Product Change Notification

POWER RESISTORS

Bourns® Fixed Resistors Product Line Announces Improvements in Power Resistor Specifications

Previous Data Sheet

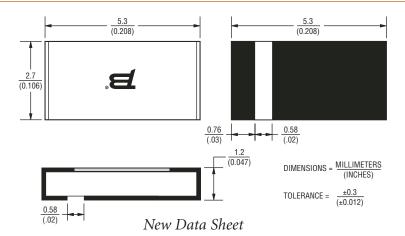
As part of Bourns commitment to product excellence, we are announcing an improvement in the dimensional accuracy of our CHF surface mount power resistors.

The marking on the surface of the chip has also been improved with a characteristic Bourns logo. The orientation of the logo is useful for determining the position of the input terminal.

The model CHF2010 will be the first model to implement these changes. The datasheet has been updated to reflect the changes.

The relevant changes are illustrated below:

The following matrix summarizes the differences in dimensions:

Parameter	Previous Datasheet (mm)	New Datasheet (mm)
Length	5.08	5.3
Width	2.54	2.7
Thickness	0.99	1.2
